Our Ref: TA/USREP/573

Subject: Part 573 Recall Notice #13V-041 - Failure of Oil Cooler Hose End Fittings

Annexe A to TA/USREP/573 Dated 25th February 2013

§573.6 Defect Information Report

EXISTING OIL COOLER HOSE INSTALLATION

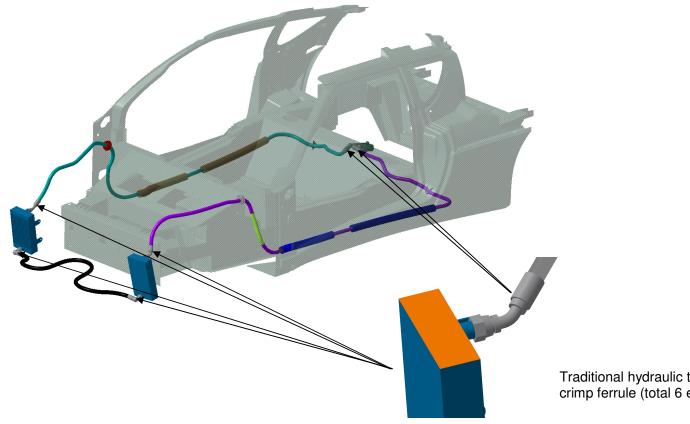
Traditional hydraulic tail and crimp ferrule (total 6 end fittings)

OIL COOLER HOSE REPAIR STRATEGY

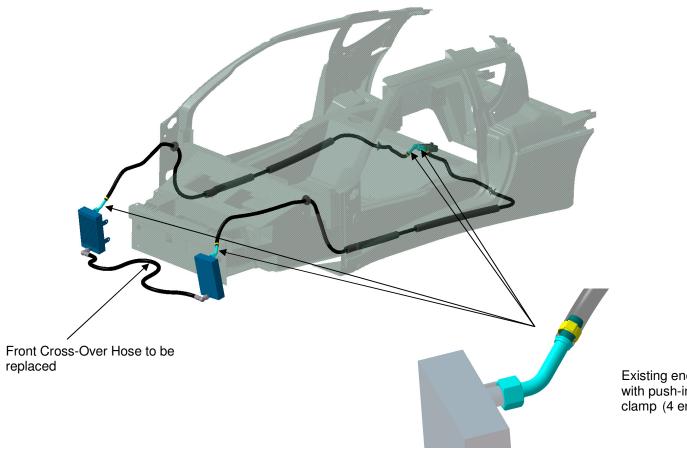
Existing end fitting to be replaced with push-in style tail with Oetiker clamp (4 end fittings)

It is proposed to replace the oil cooler hose end fittings, using a bespoke dealer fitting kit. This technique involves removal of the original hose end fittings and installing new end fittings, secured by Oetiker clamps. This repair will be carried out on the left and right longitudinal oil cooler hoses (4 end fittings). The lateral oil cooler hose will be replaced in its entirety (see Annexes D, E & F). Following repair, the vehicle will be leak checked to verify oil cooler system integrity. A customer reimbursement plan is also detailed at Annexes G & H.
